**General Electric Company Report GENE-523-A69-0594, dated June 1994,
Evaluation of the Indications Found at the H5 Weld Location in the
Dresden Unit 3 Shroud.**

**Evaluation of the Indications
Found at the H5 Weld Location
in the Dresden Unit 3 Shroud**

**General Electric Company Letter GLS 94-11, dated June 8, 1994,
Response to Commonwealth Edison Technical Audit Questions Regarding
the H5 Weld Flaw Evaluations for Dresden Unit 3 and Quad Cities Unit 1.**

SUBJECT: Response to Commonwealth Edison Technical Audit Questions

Figure 1: Most Likely Path of Crack Propagation

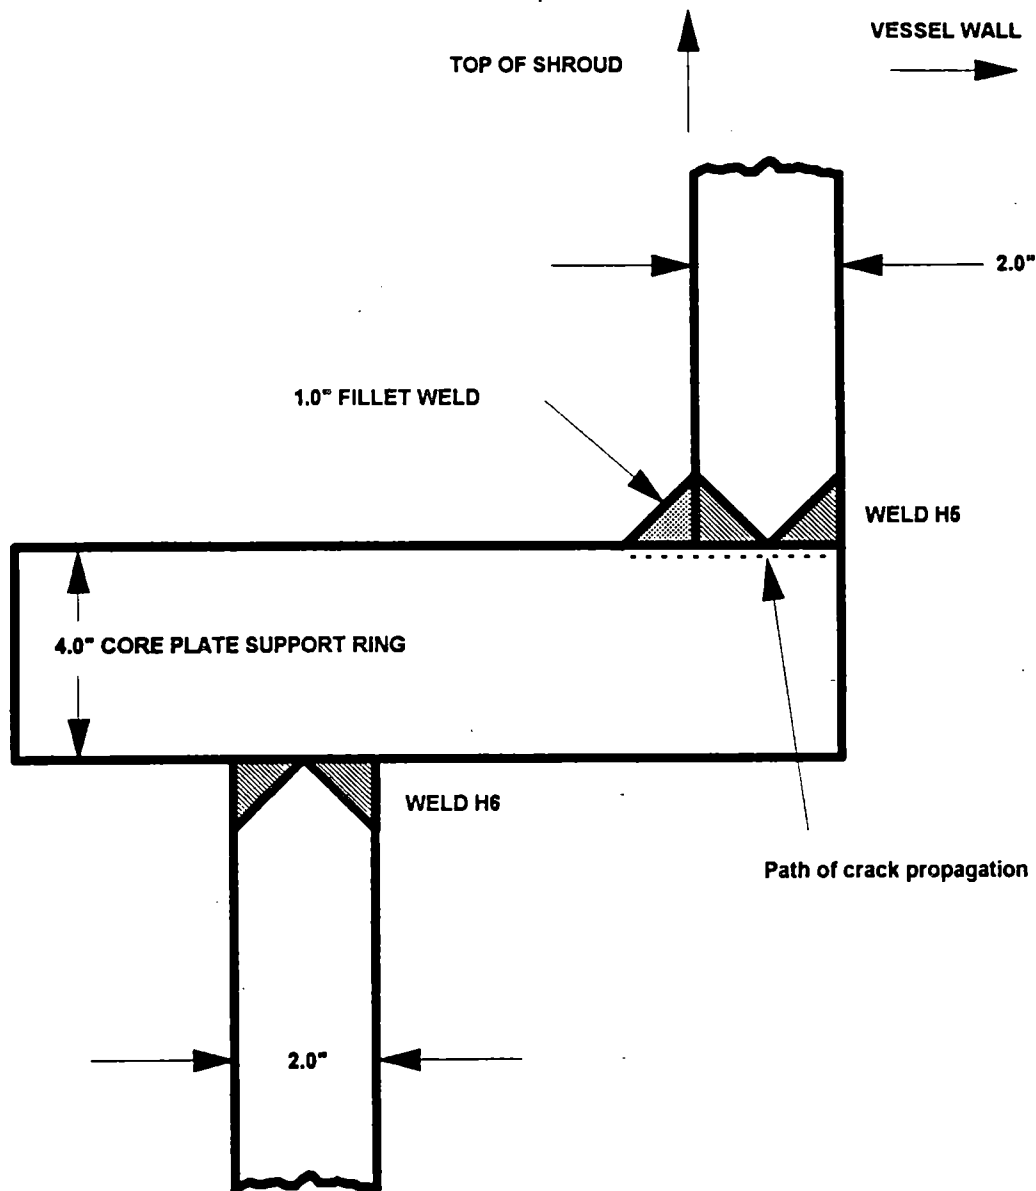
No credit was taken for the 1" fillet weld in the stress calculations performed in References 1 and 2. All of the calculated stresses were based on the shroud thickness (2 inches) alone. The 1" fillet was only considered in terms of the allowable extent of cracking for crack growth evaluation. This is reasonable since the cracking has only been observed in the core plate support ring rather than in the H5 weld itself. Because of the high end grain susceptibility, the cracking is parallel to the plane of the plate and is driven by the combination of the residual and applied stresses. Considering the in-plane growth, it is reasonable to expect that the crack follows the plate orientation as it continues through the weld heat affected zone of the fillet weld before it penetrates the material surface, as shown in Figure 1. Because of higher stress corrosion cracking resistance of the weld metal (due to duplex structure and higher ferrite), the probability

of the crack going into the weld metal (instead of the more susceptible plate material) is much lower.

Figure 2: FEM with Simulated Crack
for Determining Allowable Flaw Size

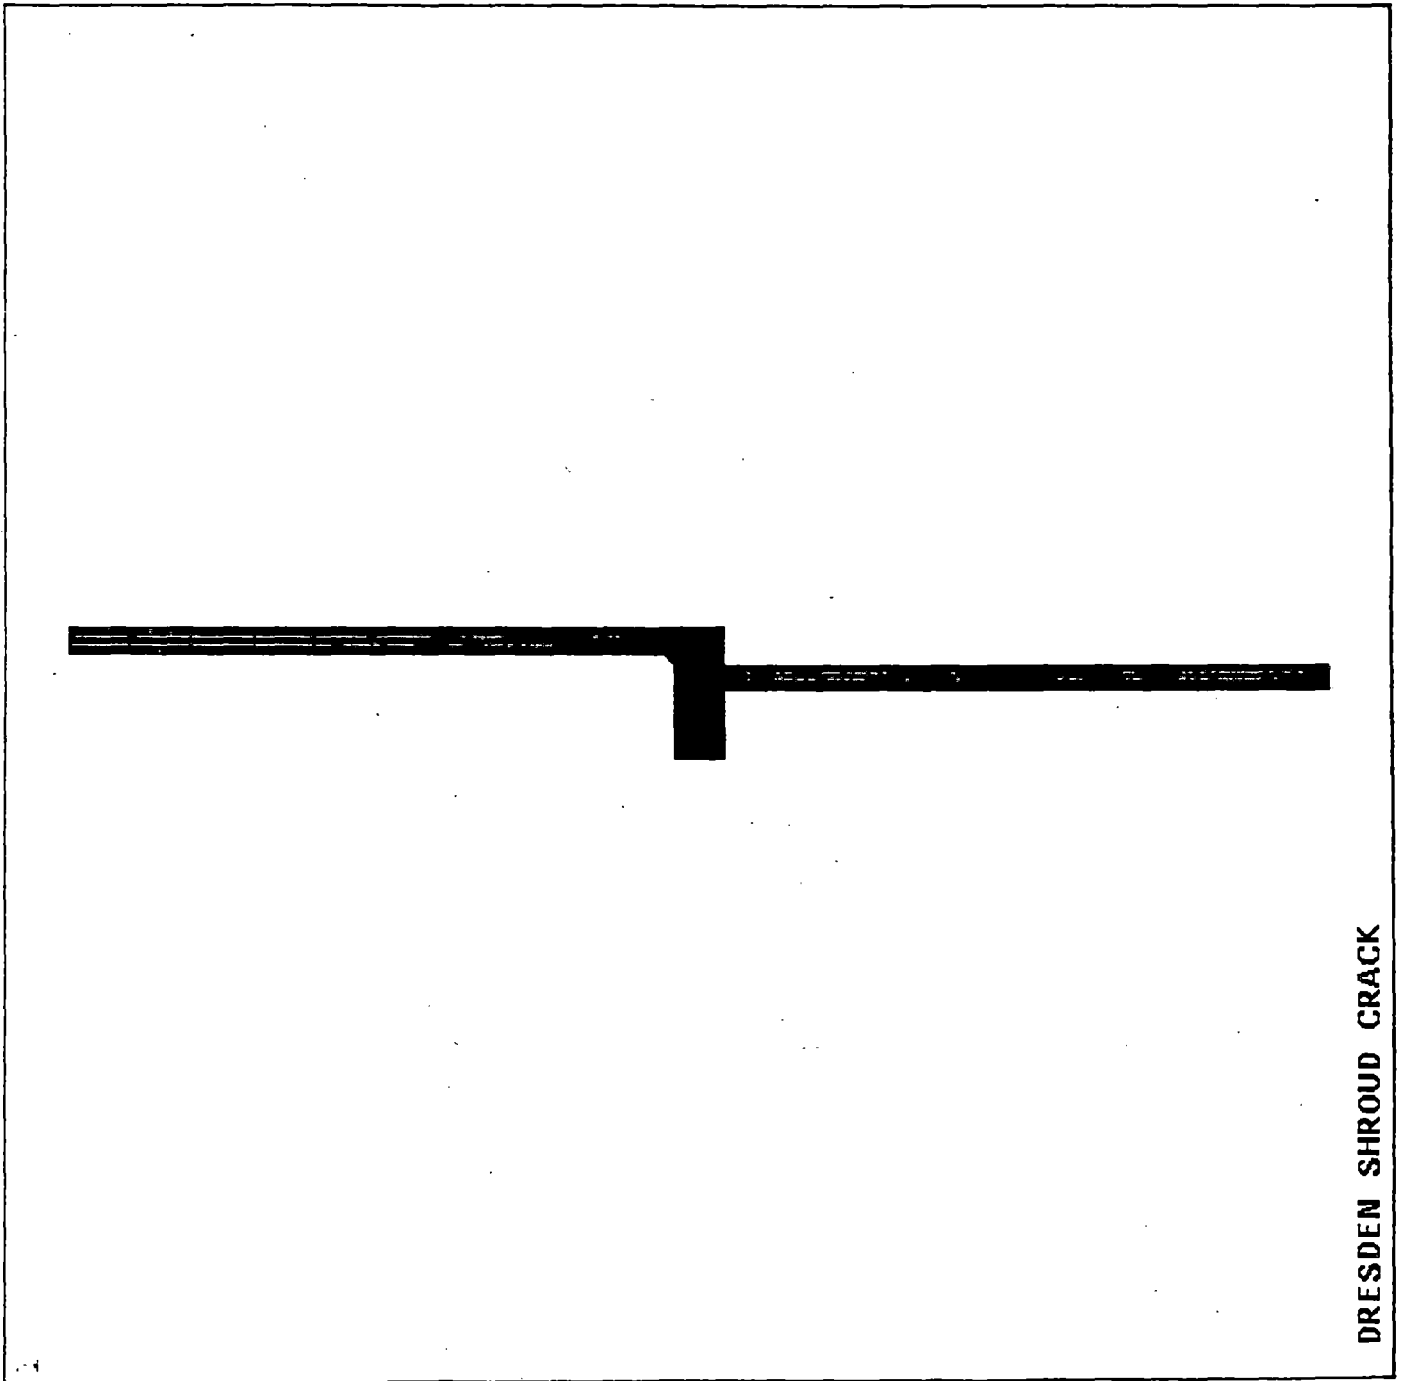
A detailed parametric finite element analysis was performed to evaluate the distribution of stresses in the H5 weld region using the ANSYS finite element computer code (Reference 8). Limit load analyses (References 1 and 2) of the shroud demonstrated that for 360° flaws, crack depths of 96% of wall thickness (i.e., $a/t = 0.96$) for Quad Cities 1, and 98% of wall thickness (i.e., $a/t = 0.98$) for Dresden 3 could be tolerated. In the H5 weld region, this corresponds to a depth of 2.88" for Quad Cities 1 and 2.94" for Dresden 3 due to the presence of the 1.0" fillet on the shroud ID. A 0.25" ligament was assumed for the purposes of this parametric finite element analysis based on modeling limitations.

The overall finite element model (FEM) is shown in Figure 2. Figure 3 shows the portion of the FEM for the region of interest. As seen from Figure 3, elements were deleted to simulate the crack. Stresses resulting from deadweight, seismic and pressure previously determined were applied to the end of the model as a membrane stress to simulate shroud loading. Loads resulting from the faulted load condition, which was previously determined to be limiting, were applied to the model including a safety factor of 1.4 consistent with ASME Code, Section XI practice.
